STID 392

RECOMMENDATION FOR CASE CLOSURE

WEATHERFORD BMW
5903 CHRISTIE AVENUE, EMERYVILLE,
CALIFORNIA
9-10-92

Figure A
Contamination Plume Based on
Total Oil and Grease in Soil Analysis

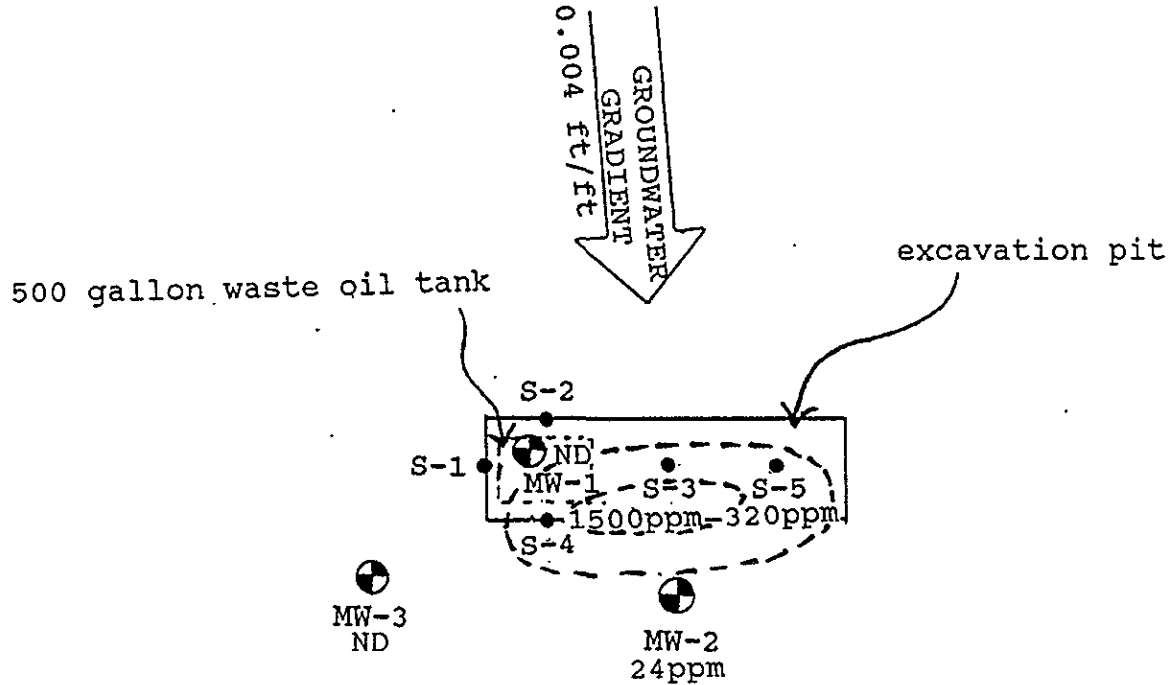
See figure A (attached) for an estimate of the localized contamination plume based on soil sampling concentrations.

Not applicable. → *ce: did you re-sample the excavation?*

Figure B
Maximum Groundwater
Total Oil and Grease Analyses

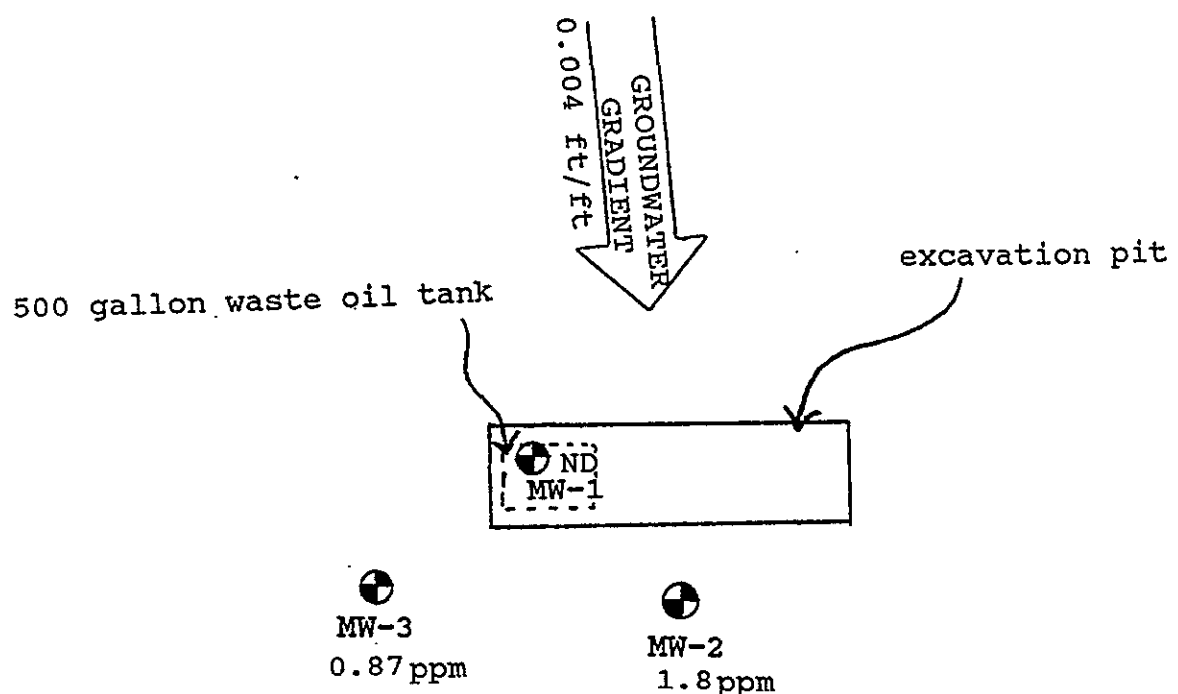
No free product was ever observed- see figure B attached and Table 1 Analytic Summary, pg 3 of C&O January 2 1992 letter report.
